香港城市規劃委員會依據城市規劃條例擬備的掃管笏分區計劃大綱圖  
TOWN PLANNING ORDINANCE, HONG KONG TOWN PLANNING BOARD  
SO KWUN WAT - OUTLINE ZONING PLAN

核准圖編號 S / T M - S K W / 1 3 的修訂  
AMENDMENT TO APPROVED PLAN No. S/TM-SKW/13

圖則編號  
PLAN No. S/TM-SKW/13A

Proposed Amendment to the Approved So Kwun Wat Outline Zoning Plan  
No. S/TM-SKW/13 for Redevelopment of Correctional Services Department's  
Staff Quarters at Hong Fai Road, Siu Lam

AMENDMENT ITEM A

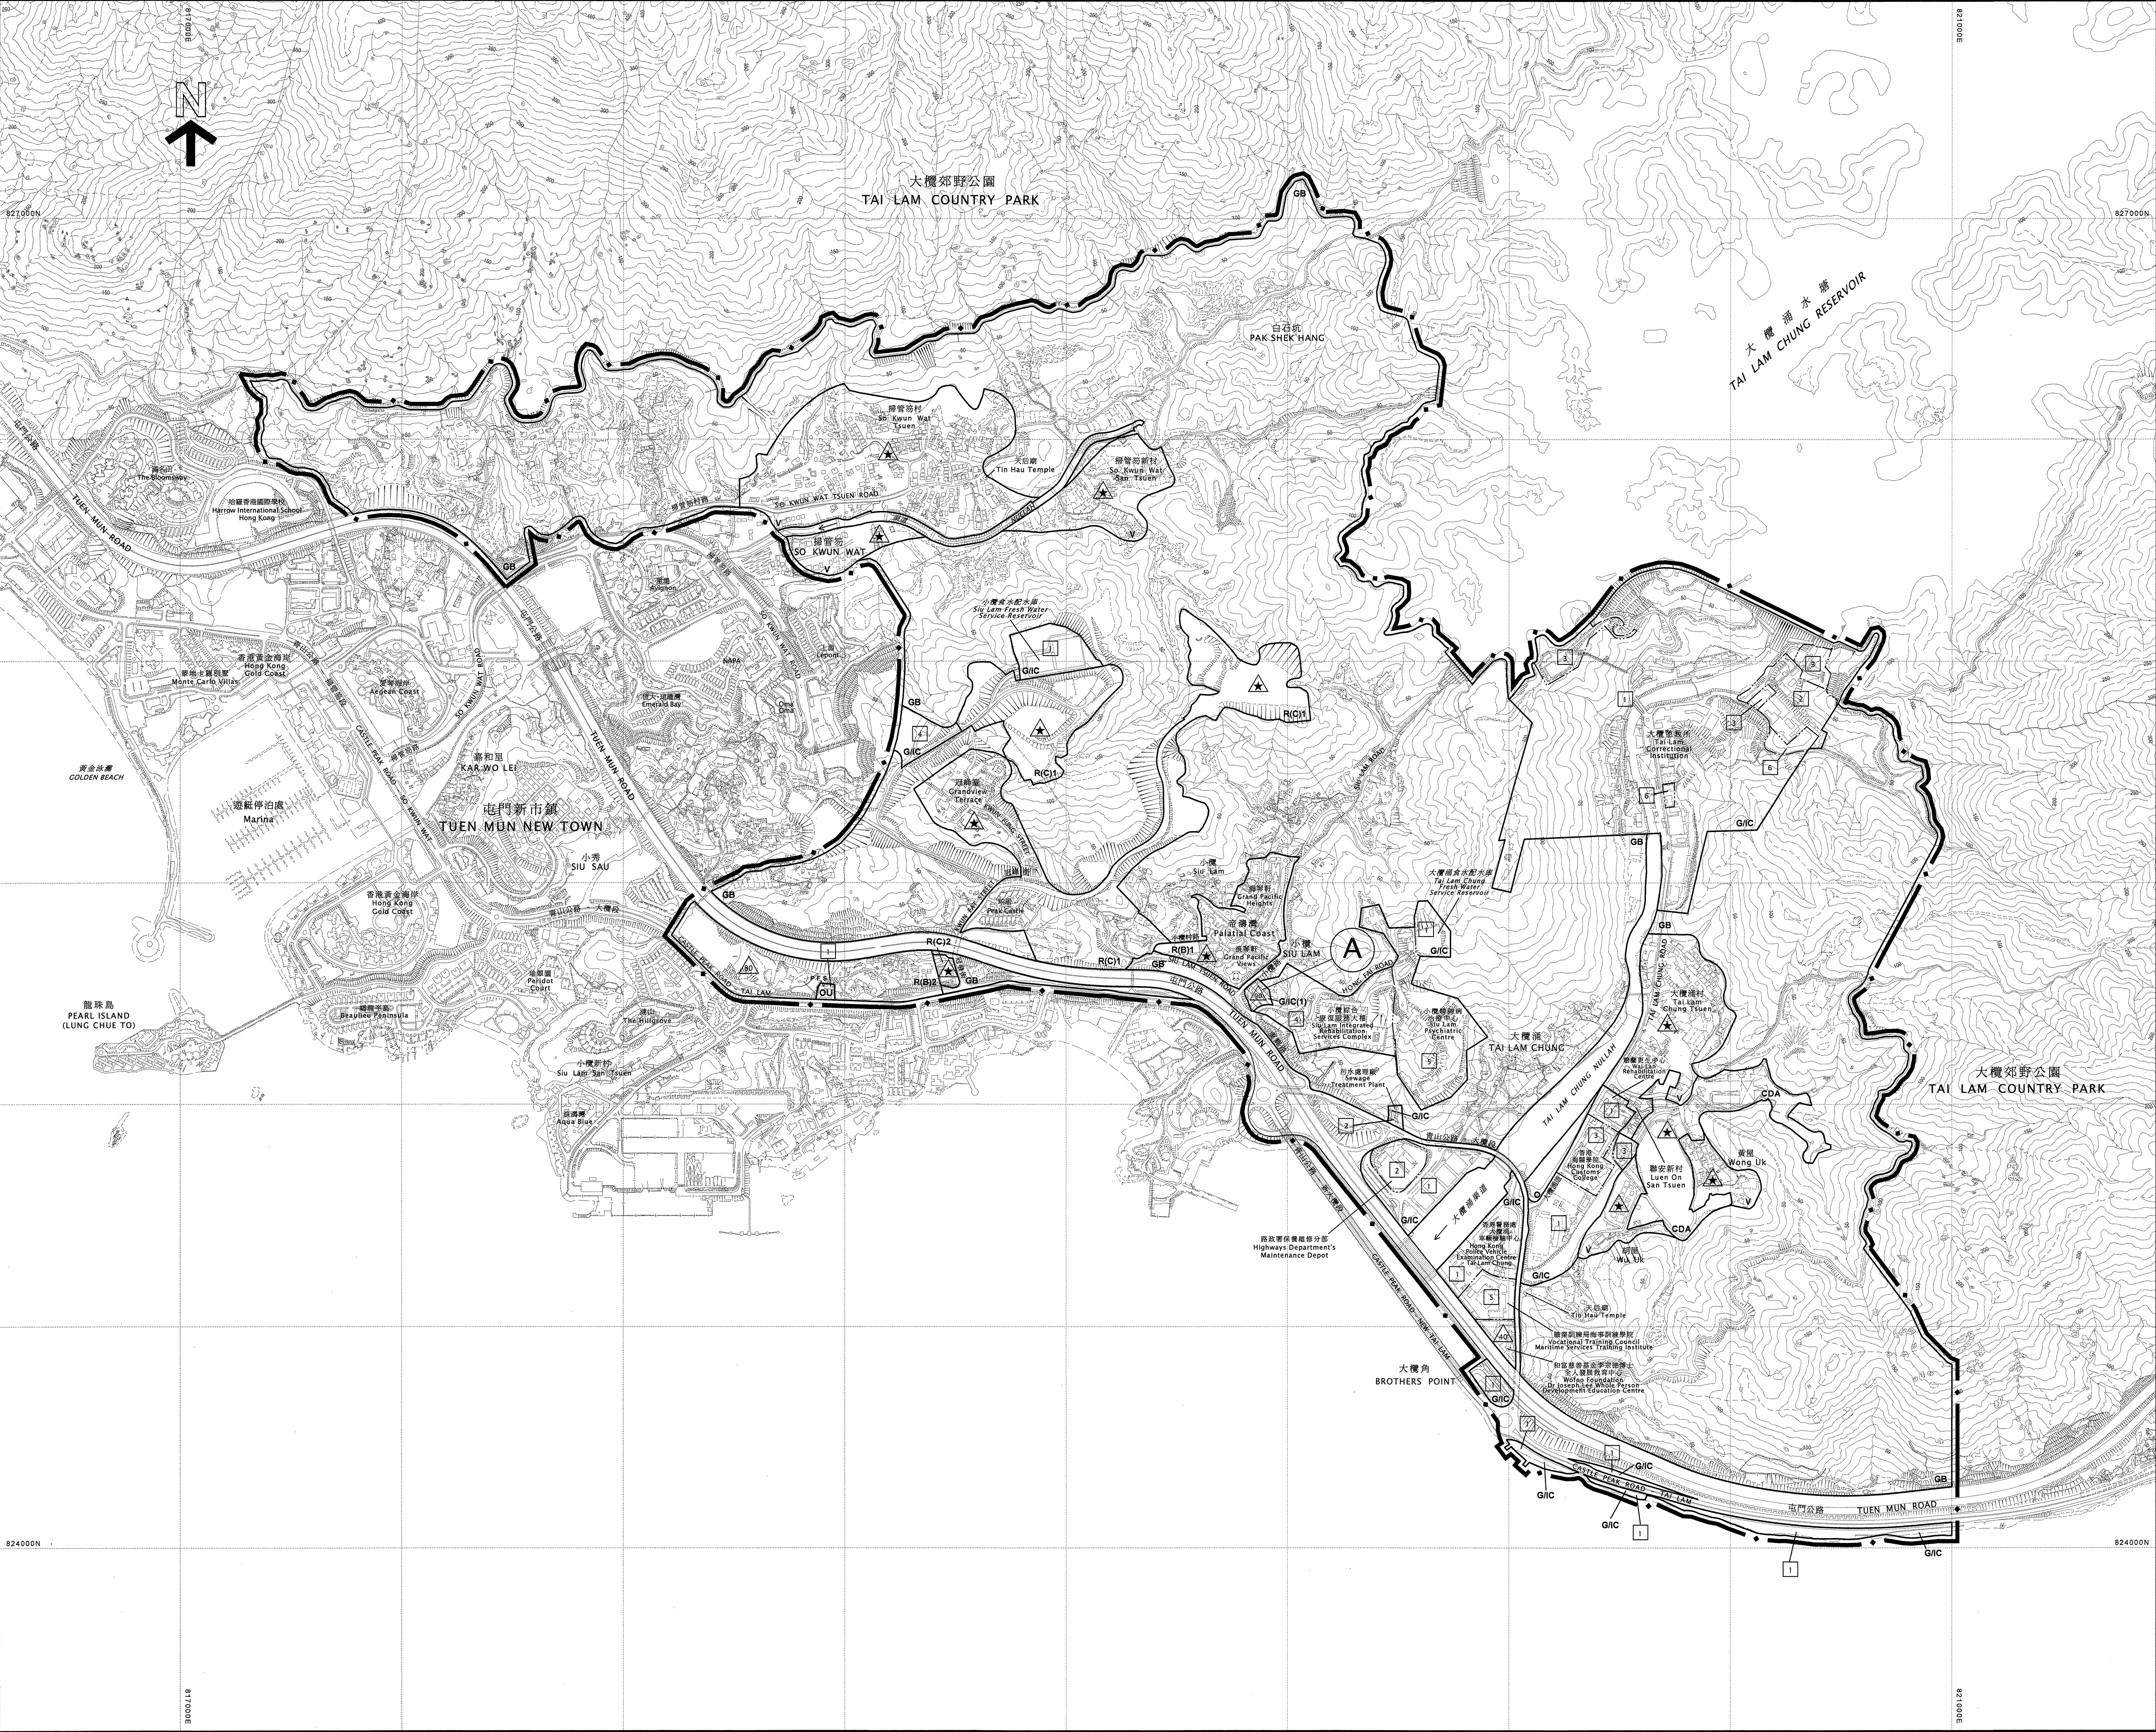
（參看附表）  
（SEE ATTACHED SCHEDULE）
